Economic Commission for Europe

Global Forum for Road Traffic Safety

Amendment proposals to the 1968 Convention on Road Signs and Signals

Submitted by Lithuania and Luxembourg

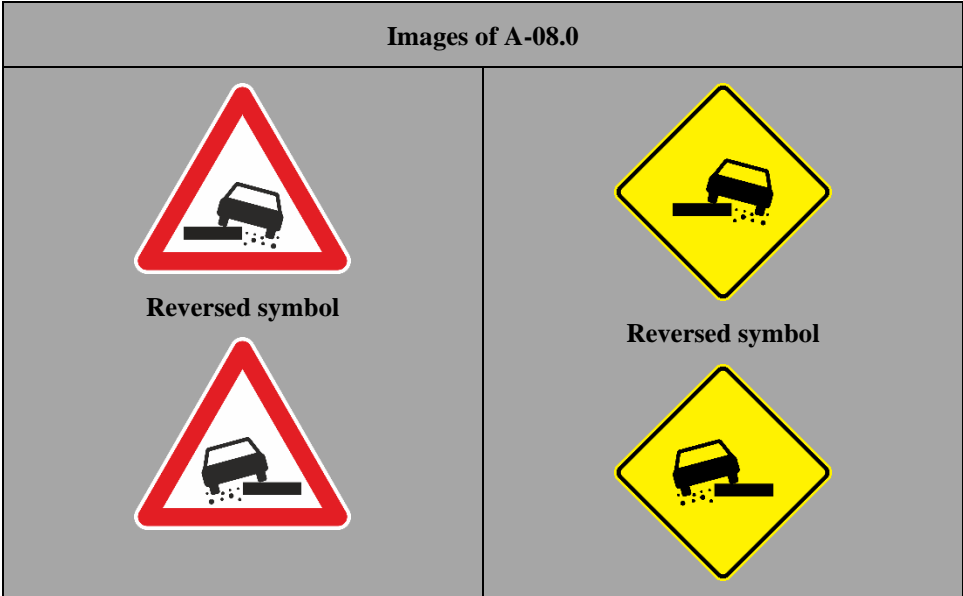
~~(b) The symbol may be reversed.~~

A-08.0 gives warning of a section of road where the shoulders are particularly dangerous. The symbol on this sign may be reversed.

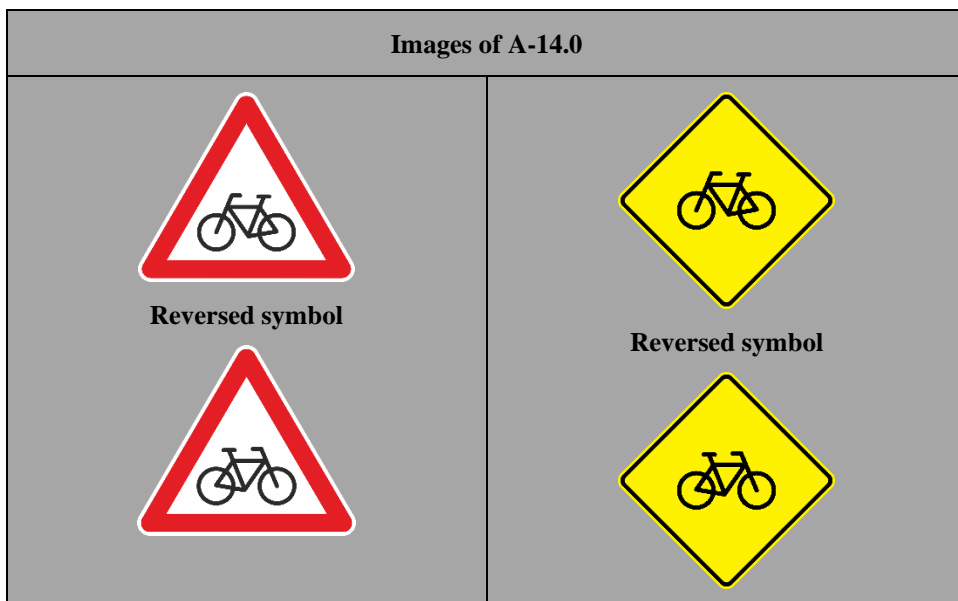
(b) ~~The symbol may be reversed.~~

A-14.0 gives warning of a point at which cyclists frequently enter or cross the road. The symbol on this sign may be reversed.

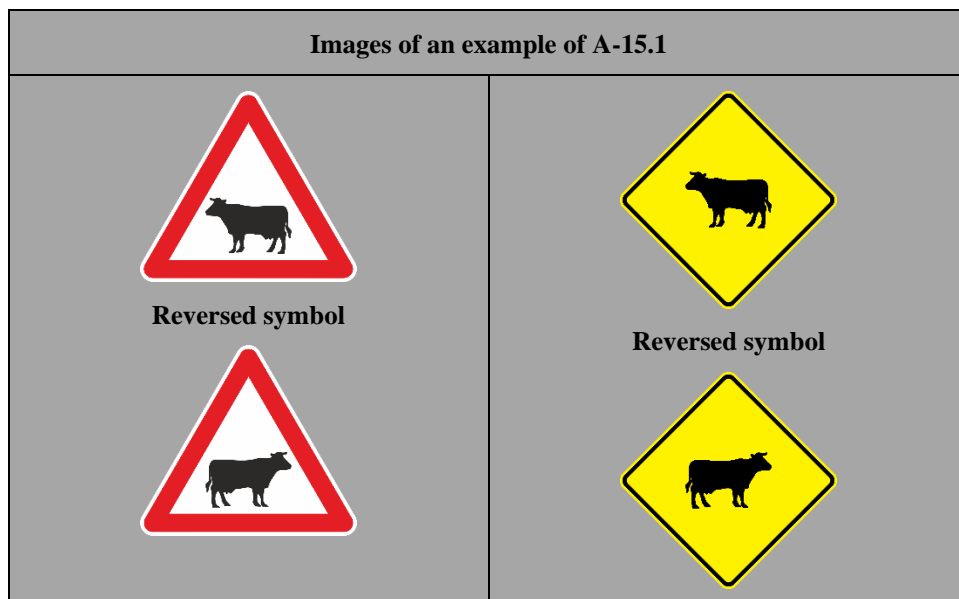
(b) ~~The symbol may be reversed.~~

A-15.1 gives warning of a section of road on which there is a particular danger of domestic animals crossing. The symbol shall represent the silhouette of the domestic animal most frequently encountered. The symbol on this sign may be reversed.

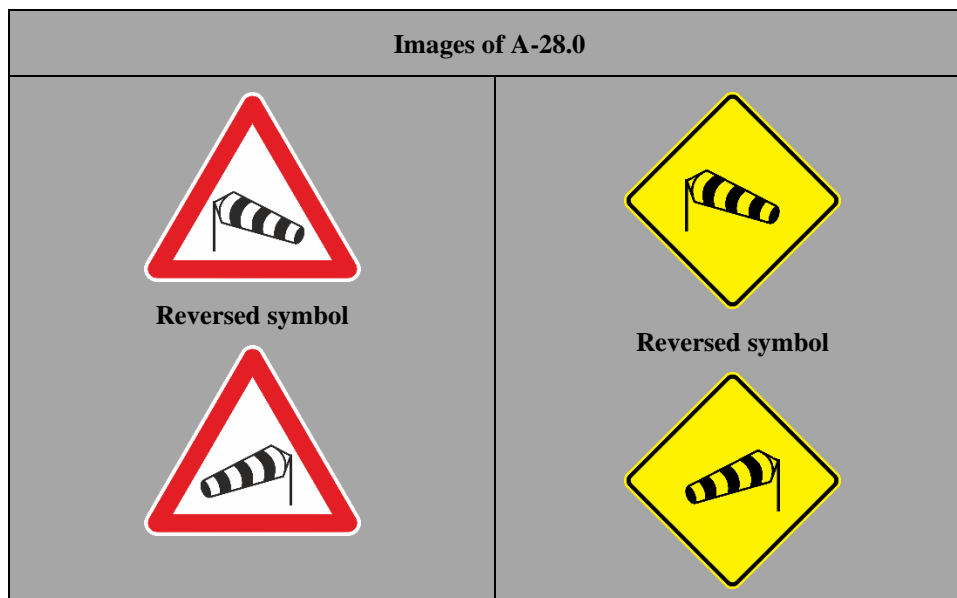
(b) ~~The symbol may be reversed.~~

A-28.0 gives warning of a section of road on which there is often a strong cross-wind. The symbol on this sign may be reversed.

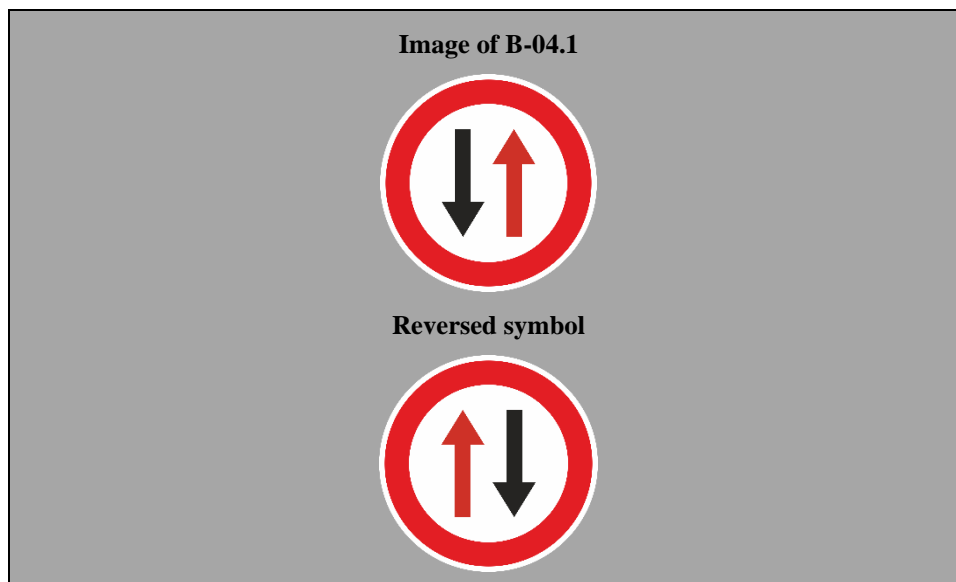
(b) This sign shall be round, with a white or yellow ground and **with** a red border; the arrow indicating the direction having priority shall be black and that indicating the other direction red. **The arrows shall be parallel.**

**EMERGENCY TELEPHONE**

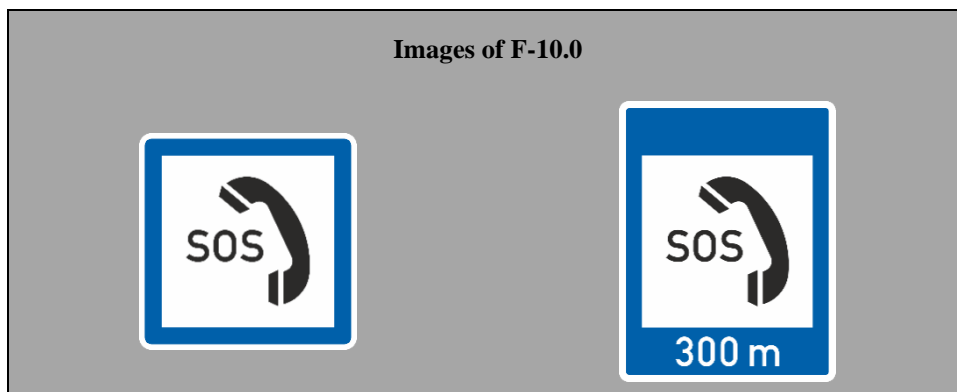
F-17 "EMERGENCY TELEPHONE" F-10.0 notifies of a location of a telephone for emergency calls. The symbol may also be red.

**EXTINGUISHER**

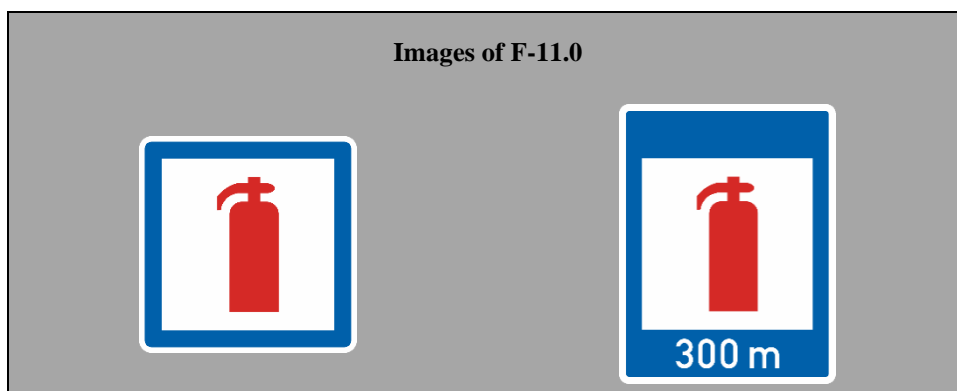
F-18 "EXTINGUISHER" F-11.0 notifies of a location of an extinguisher. The symbol shall be red.
